RE: **Gonzales Residence** 9801 Cody Ct NW Requested for Permanent C. O. - Not Accepted Engineers Stamp Date 11/4/16 (B12D013) **Certification dated: 4-3-17**

Based on the certification provided in your submittal received 4/3/2017, the above referenced site cannot be accepted for release of Certificate of Occupancy by Hydrology until the following comments are addressed:

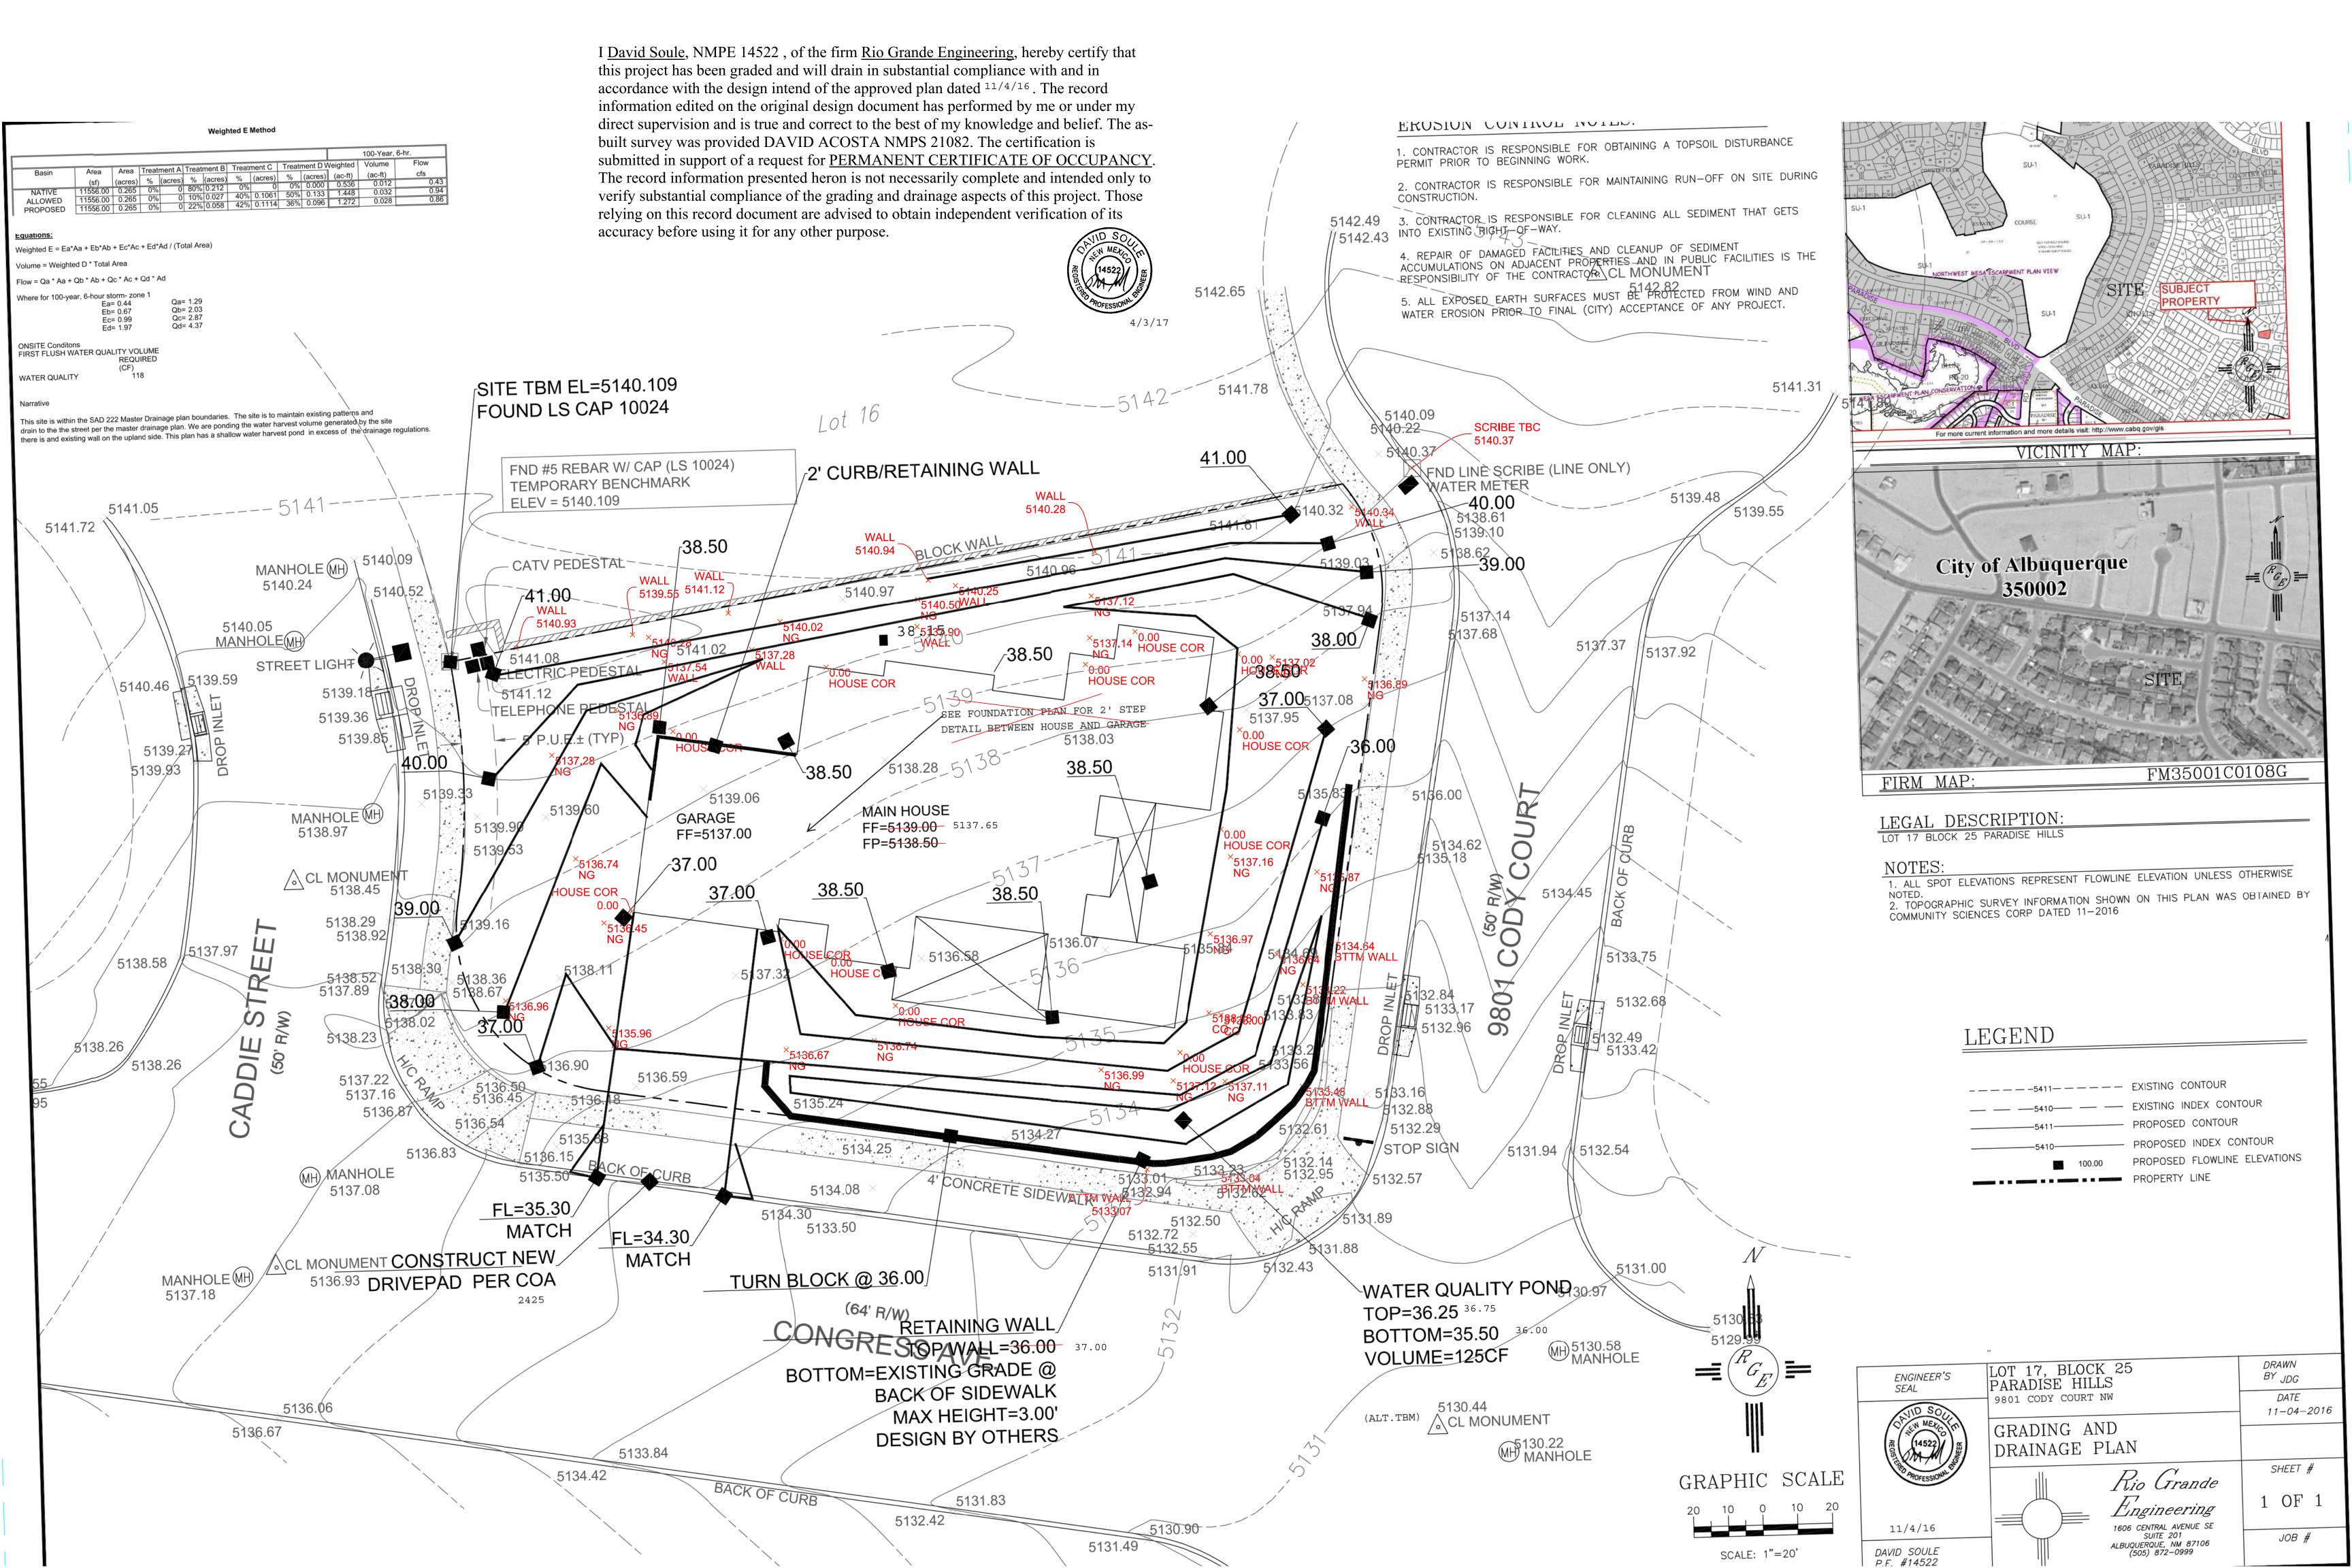
The pond in the front yard is incomplete.

A wall that is not on the approved plan was constructed the middle of front yard pond.

- - clarification. Construction debris covers the front yard and impedes the flows on the west side of the . front yard that are coming from the backyard.

The approved drawing calls out the garage wall as a 2' curb/retaining wall. Needs

• There is no Turn Block @ 36" in the front yard retaining wall.

An inspection by our office will need to take place after these corrections are made.
